RESPONSE TO PLANNING RELATED TO PLANNING APPLICATION A/266/21PL

Impact to numbers 5 & 6 The Beeches:

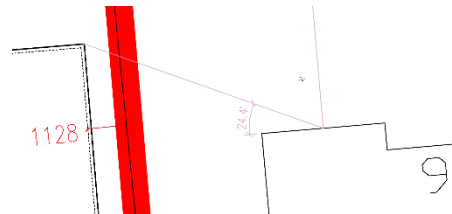
Increase in noise: As Dappers lane is further developed there will be more traffic and hence noise on the lane. However, having the 2 new houses “in the way” of the road noise on Dappers lane, it will if anything attenuates the noise for residents at number 5 and 6. The additional tree planting proposed on both the front and rear boundaries of the site will further improve noise attenuation. I would accept that during construction there will potentially be more noise, but we would be happy to accept a planning condition on the scheme to reduce hours of working to after 08:00 on weekdays and not to work on weekends. We don’t want to be bad neighbours.

Overbearing scale:

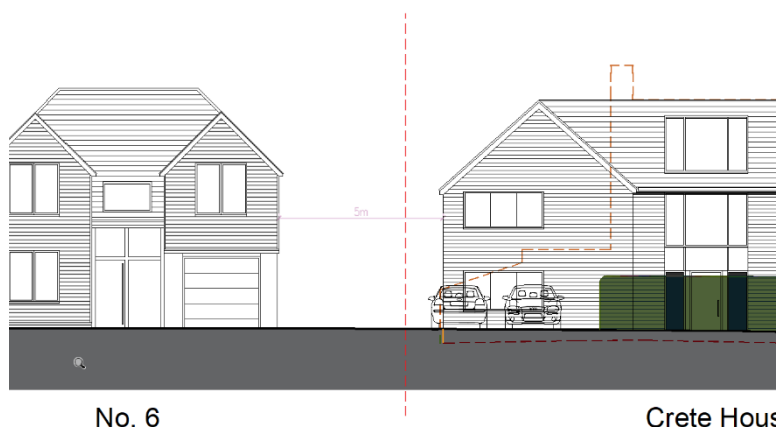
The house-to-house separation between Crete House and 6 the Beeches is over 5 meters away, so any over shadowing/overbearing is significantly less than that between the current houses at The Beeches where the house-to-house separation is 2.7 to 2.8m.

The proposed new dwellings are over 13m away from the boundary to number 6 and will not cause any overbearing.
